# COMMONWEALTH of VIRGINIA

DEPARTMENT OF TRANSPORTATION  
1401 EAST BROAD STREET  
RICHMOND, VIRGINIA 23219-2000

January 9, 2004

## MEMORANDUM

SHEET 1 OF 2	<p>STANDARD CURB DROP INLET</p> <p>12" - 24" PIPE: MAXIMUM DEPTH (H) = 9'</p> <p>VIRGINIA DEPARTMENT OF TRANSPORTATION</p>	SPECIFICATION REFERENCE
<p>REV. 01/04.</p> <p>104.03</p>		<p>233</p> <p>302</p>

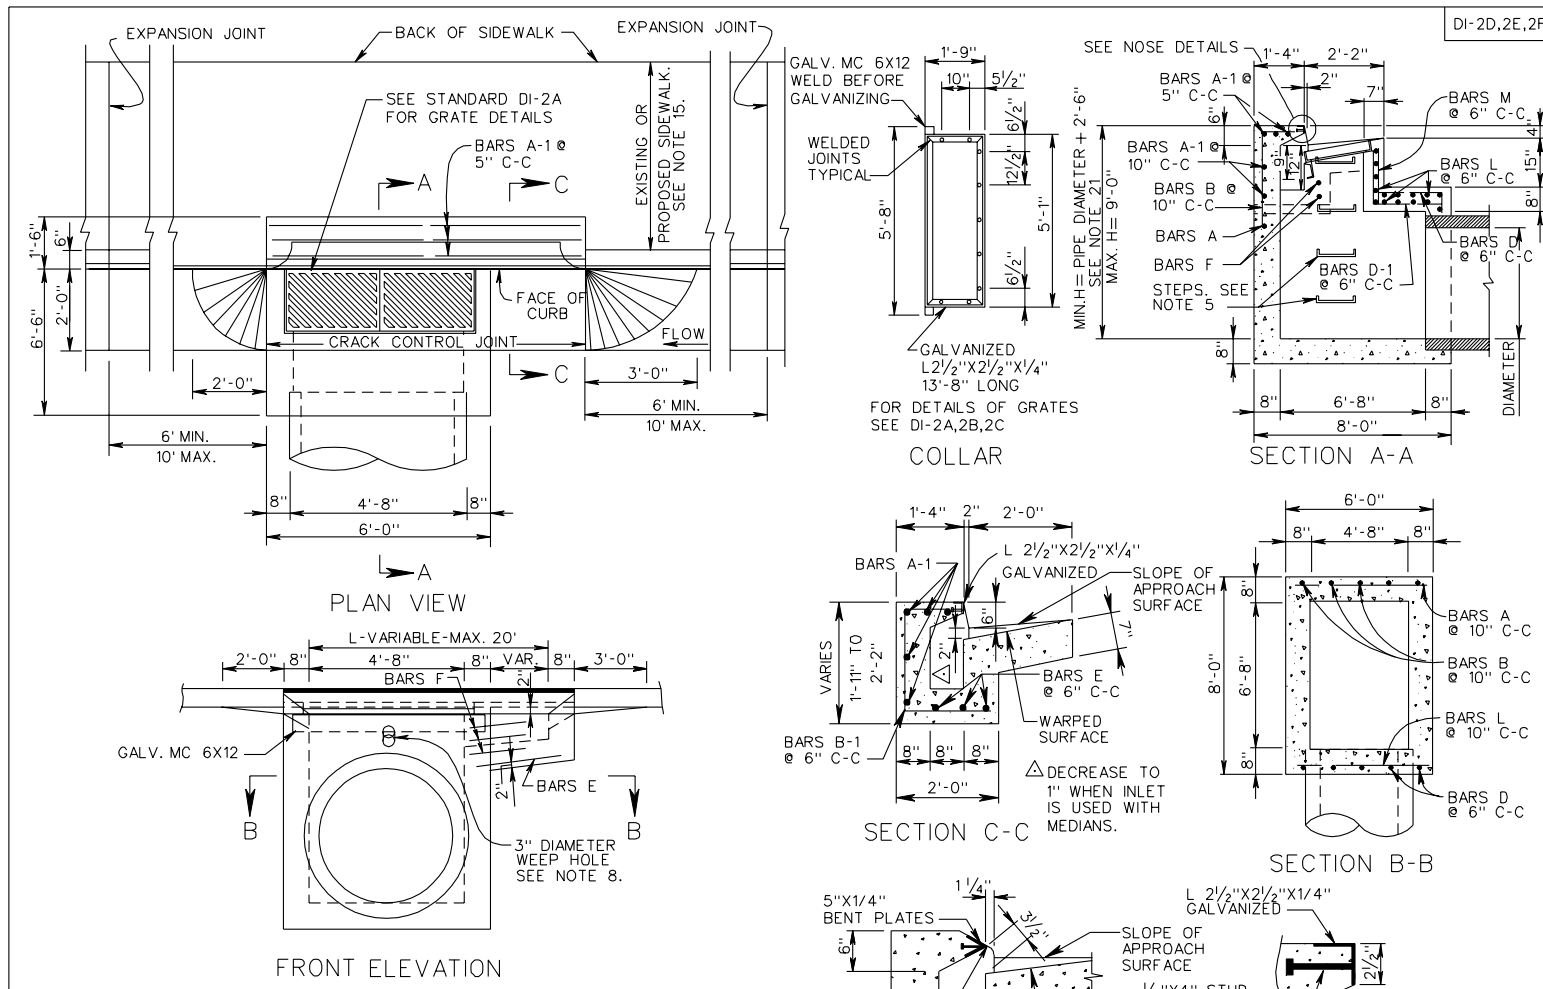
PAGE	INSERT	STANDARD	REVISION
104.03	A153	DI-2A,2B,2C	Revised details showing approach surface to slot.
104.06	A153	DI-2D,2E,2F	Revised details showing approach surface to slot.

107.00

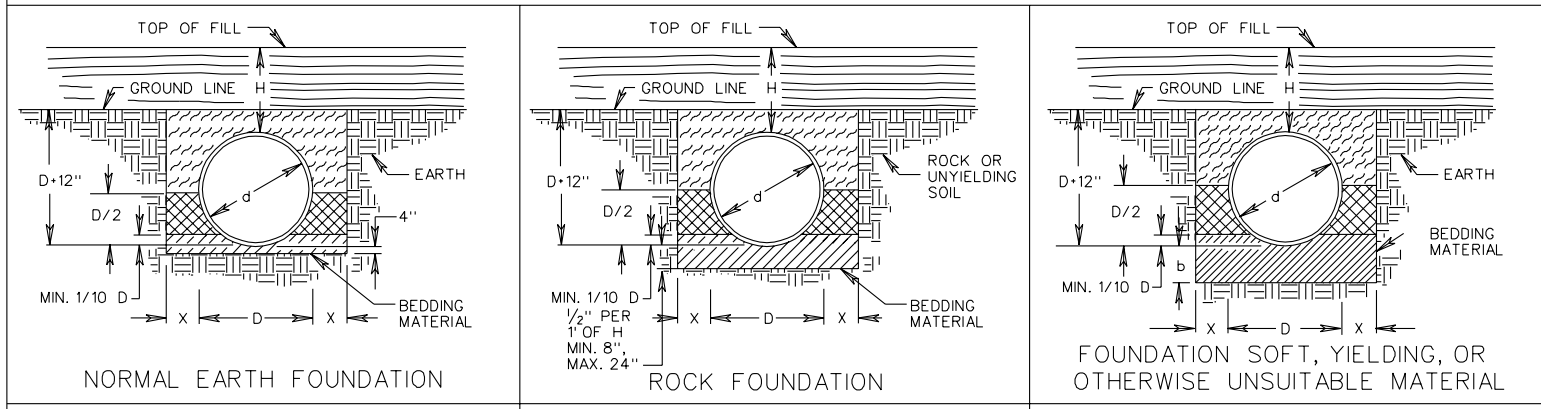
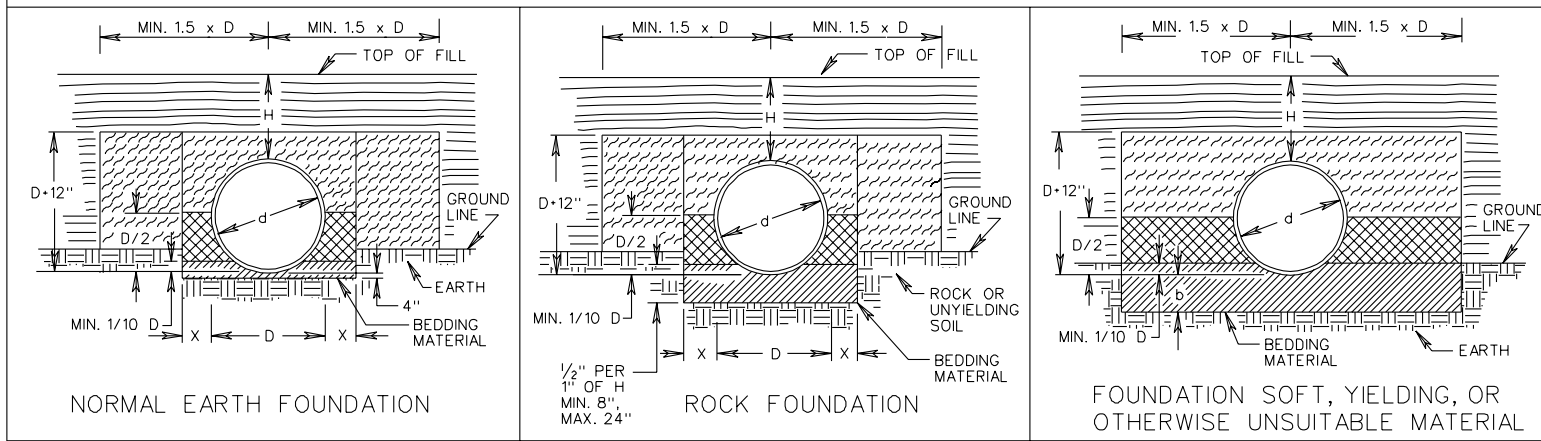
<b>PAGE</b>	<b>INSERT</b>	<b>STANDARD</b>	<b>REVISION</b>
107.00	A151	PB-1	Added Notes Page
107.01	A86	PB-1	Removed requirement for class II backfill
107.02	A86	PB-1	Removed requirement for class II backfill
107.03	A120	PB-1	Removed requirement for class II backfill
107.04	A120	PB-1	Removed requirement for class II backfill
108.06	A81	UD-4	Removed inspection port and modified outlet pipe configuration.
115.01	ISD414.04	ESC-INS	Revised entrance width from 12" to 12'
203.02	A78	CG-9B	Revised Notes.
203.03	A78	CG-9D	Revised Notes
203.05	A59	CG-12	Revised notes and dimensions.
203.06	A59	CG-12	Revised notes and dimensions.
203.07	A59	CG-12	Revised notes and dimensions.
203.08	A108	CG-13	Revised notes and dimensions.

REV. 1/04  
301.14

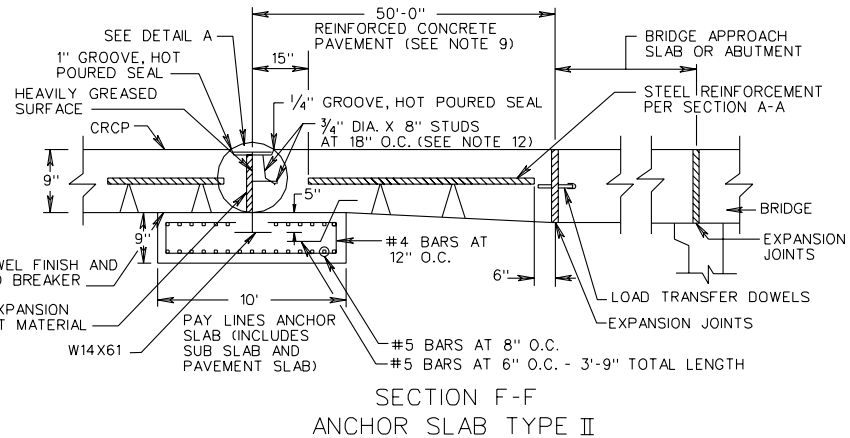
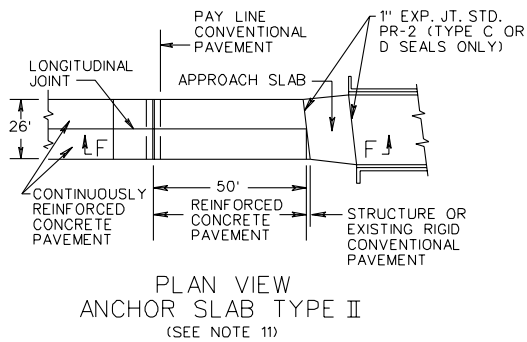
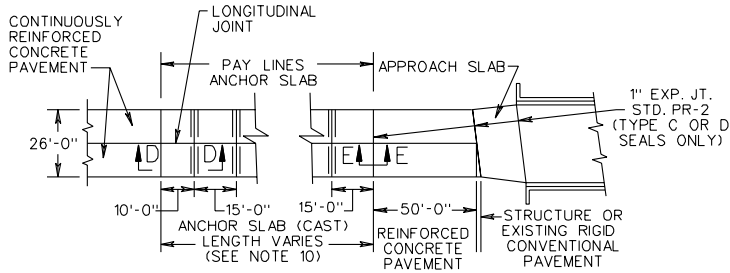
<b>PAGE</b>	<b>INSERT</b>	<b>STANDARD</b>	<b>REVISION</b>
301.14	ISD2623	PR-5	Revised anchor slab detail.
301.17	ISD2724	PR-6	Revised anchor slab detail.

REV. 1/04  
301.20

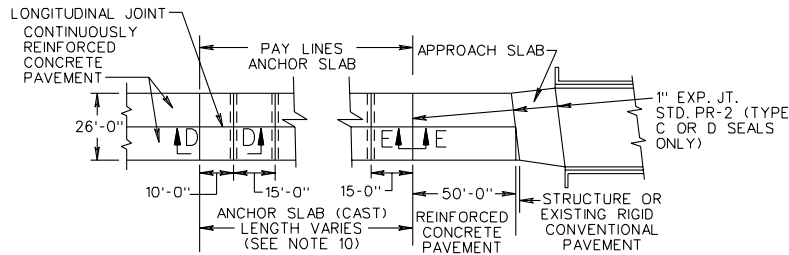
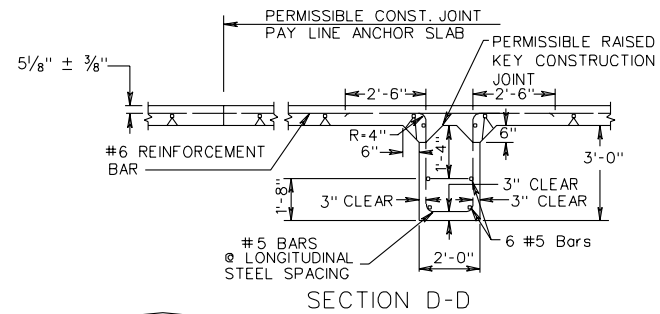
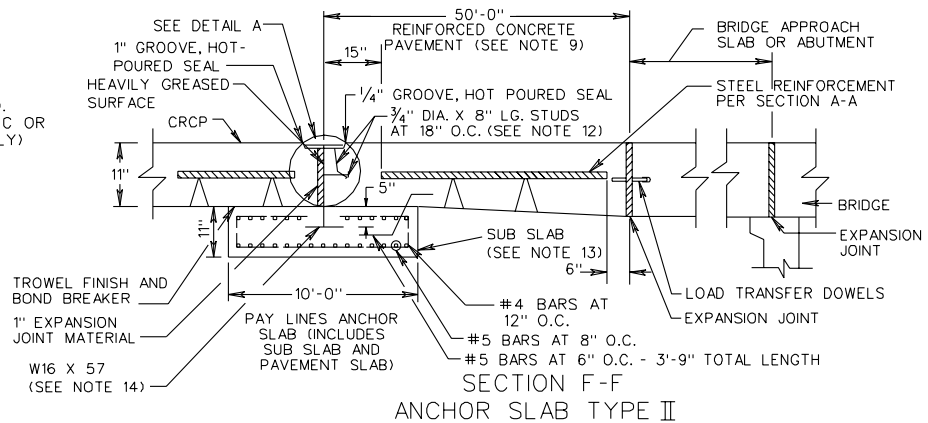
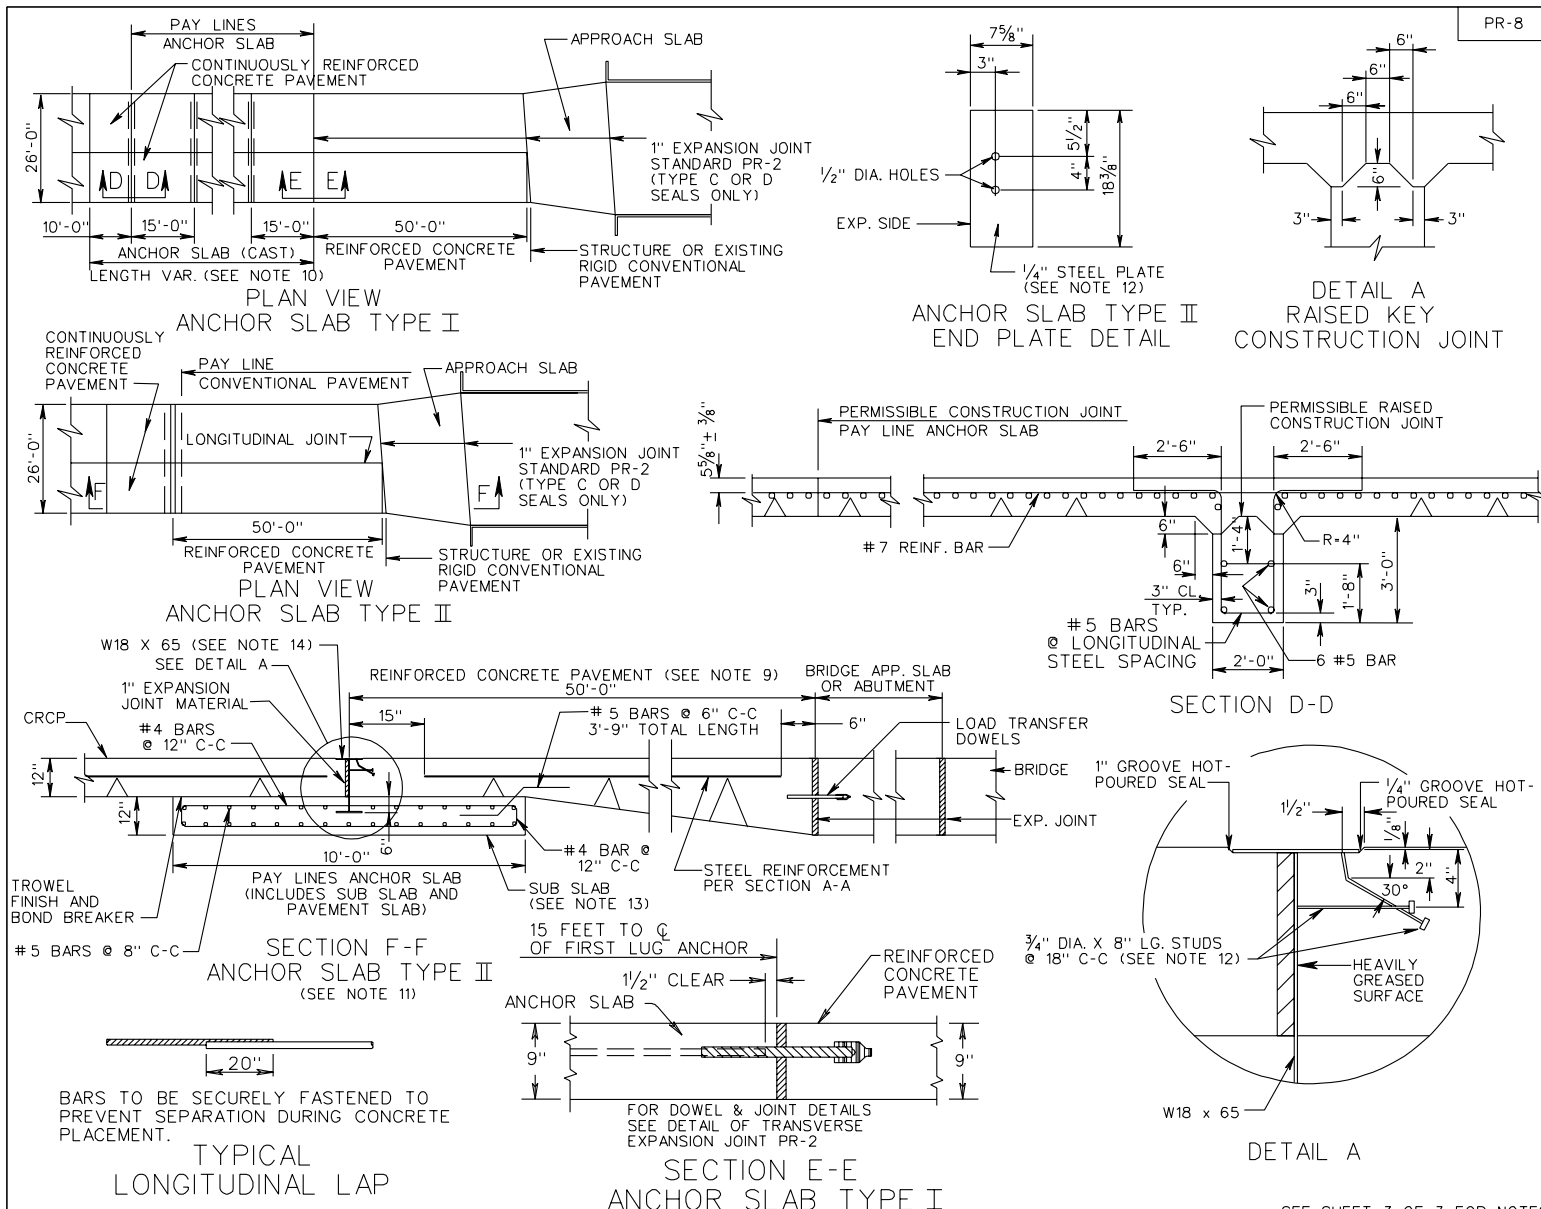
301.20	ISD2761	PR-7	Removed load transfer dowel into bridge (section F-F).Revised anchor slab detail.
301.23	ISD2861	PR-8	Removed load transfer dowel into bridge (section F-F).Revised anchor slab detail.

REV. 1/04  
501.15

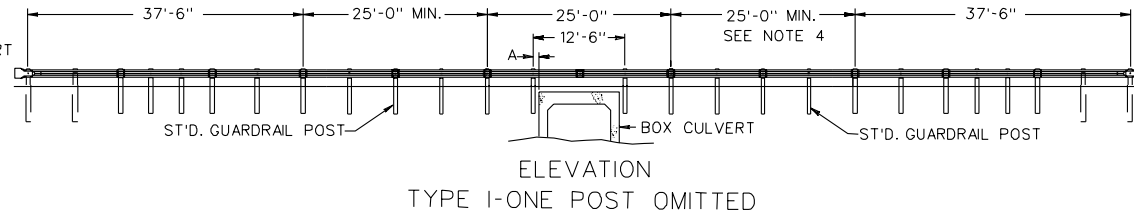
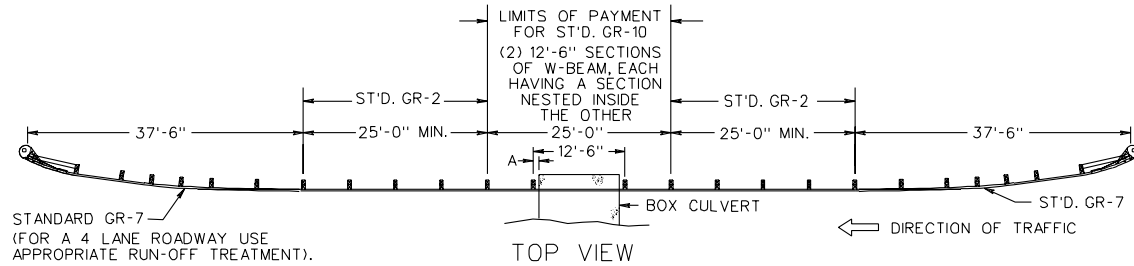
301.26	ISD2862	PR-9	Removed load transfer dowel into bridge (section F-F).Revised anchor slab detail.
501.15	A91	GR-8,8A,8B,8C	Revised notes referring to limits of item.

REV 1/04  
501.19

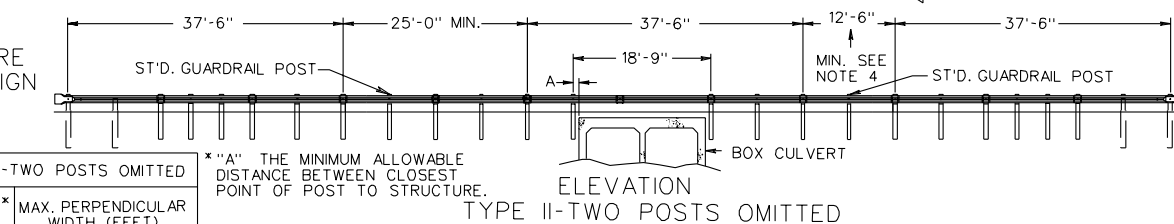
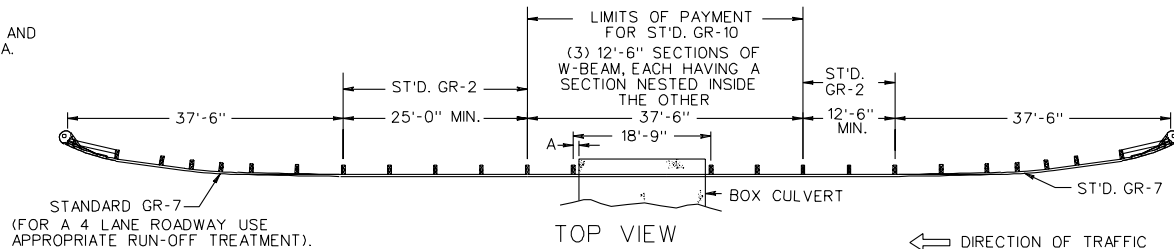
501.19	A88	GR-10	Revised note to remove reference to splice plate.
501.20	A88	GR-10	Revised detail changing text from "Clear Zone" to "Dynamic Deflection". Revised note to remove reference to splice plate.

501.39

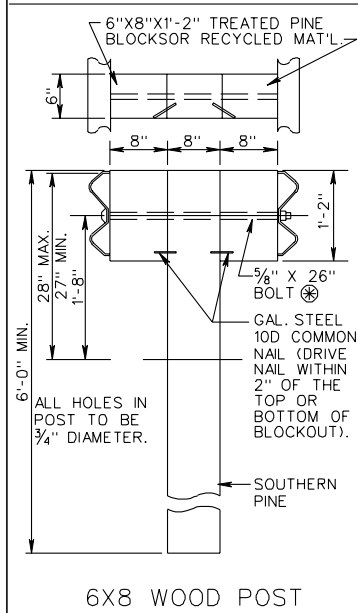
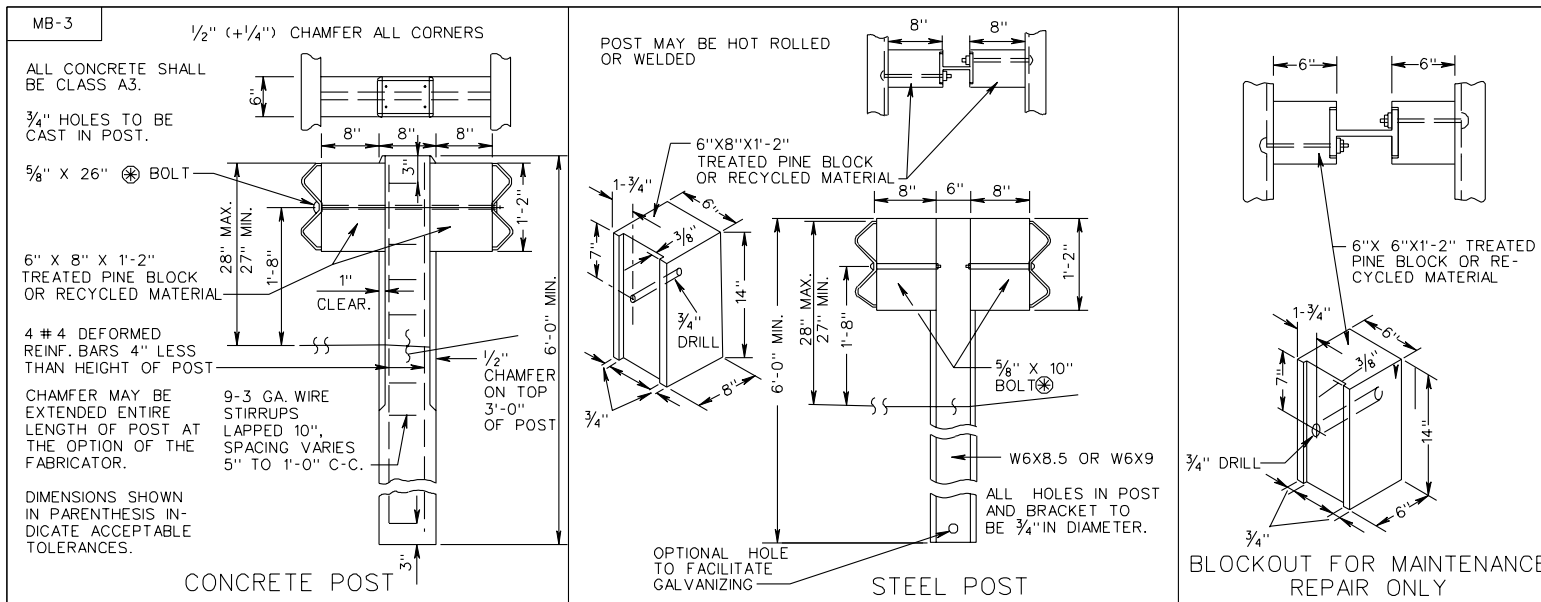
501.39	A93	GR-INS	Added detail for transition from old GR-8 to current standard.
501.41	A94	MB-3	Revised flare rates.
501.44	A98	MB-7D, 7E, 7F	Revised flare rates.

REV.1 /04  
501.45

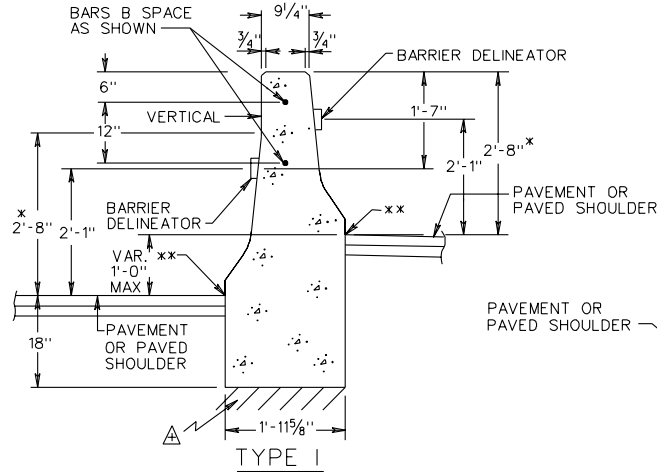
501.45	A103	MB-7D PC	Revised flare rates.
501.47	A98	MB-8A	Revised flare rates

501.56

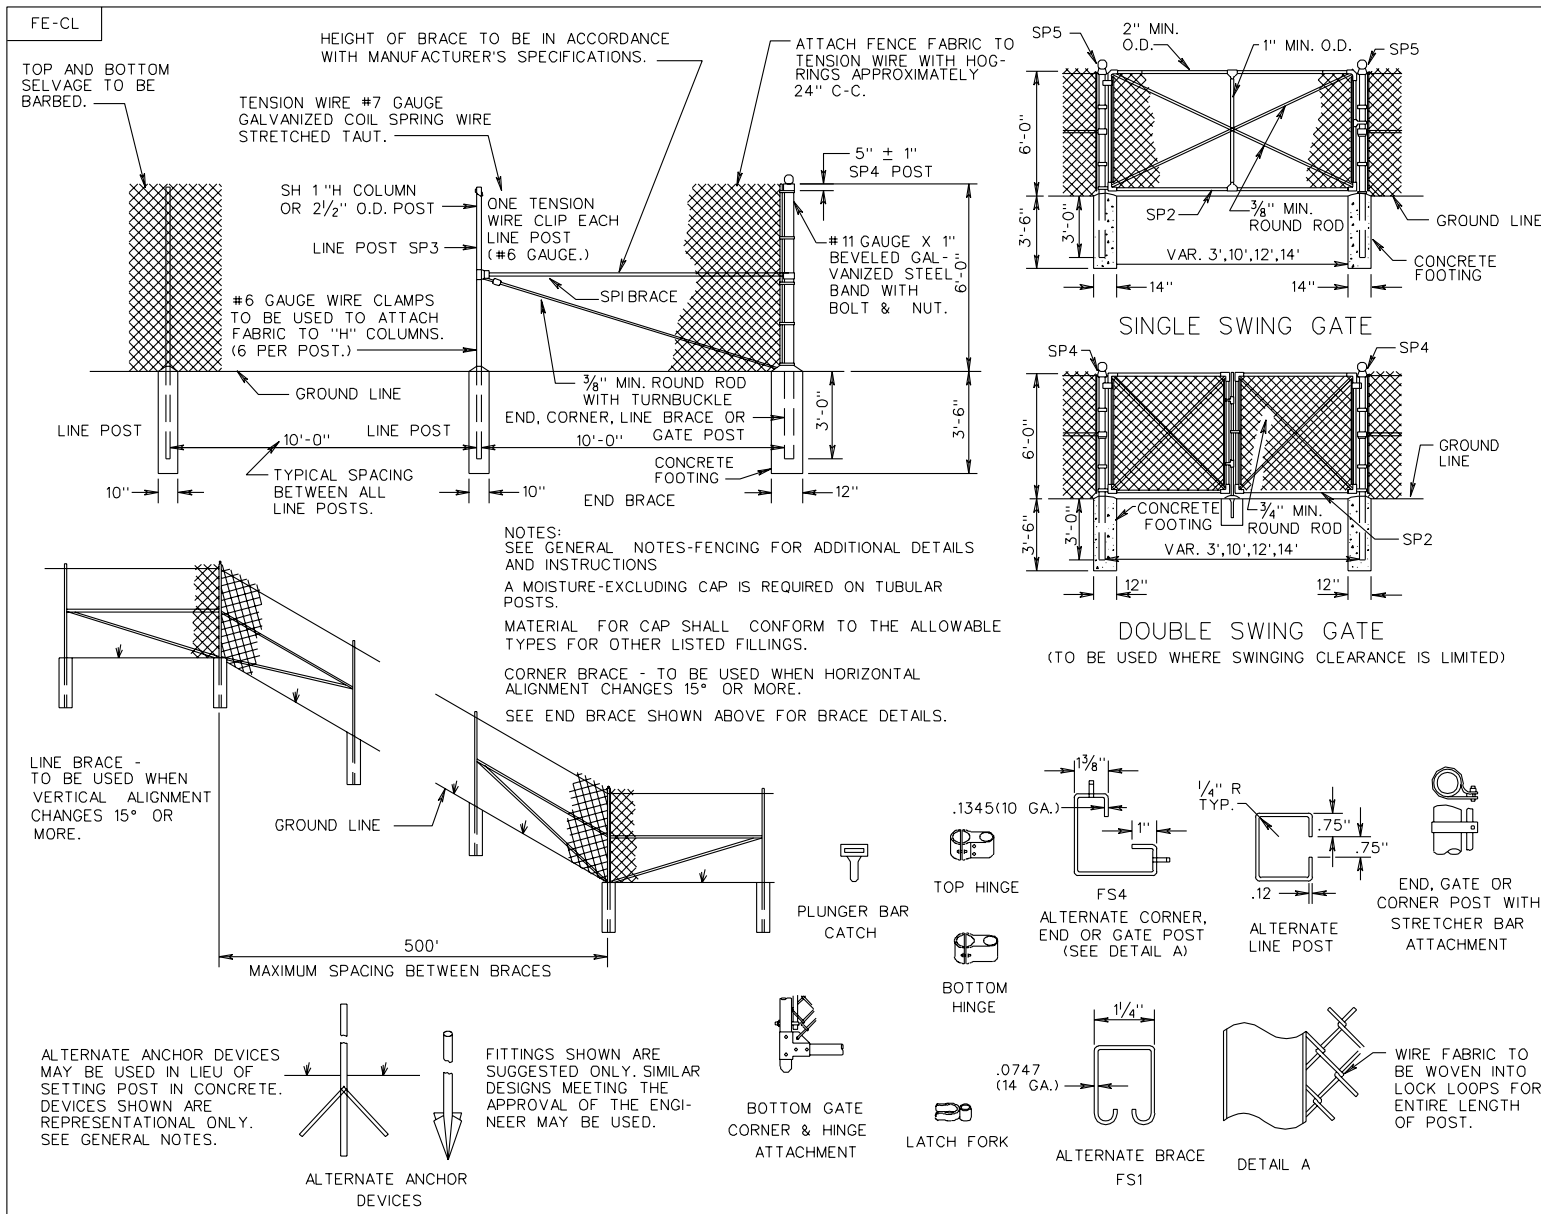
<b>PAGE</b>	<b>INSERT</b>	<b>STANDARD</b>	<b>REVISION</b>
501.56	A96	MB-12A,B,C	Revised flare rates.
501.58	A104	MB-13	Revised flare rates.
502.04	A152	FE-CL	Revised Specification Designation of post sizing.
502.07	A152	FE-6	Revised notes.
603.02	A149	RFD-1	Revised table dimension from Ft. to In.
1301.72	A154	OSS-1	Added Note #6 and revised fixed object offset distance.
1301.73	A154	OSS-1	Deleted catwalks and replaced details with electrical installation details and added a contactor.
1301.74	A155	OSS-1	Replaced details with sign panel erection details and sign lighting details.
1301.75	A155	OSS-1	Replaced details with sign panel erection details and sign lighting details.
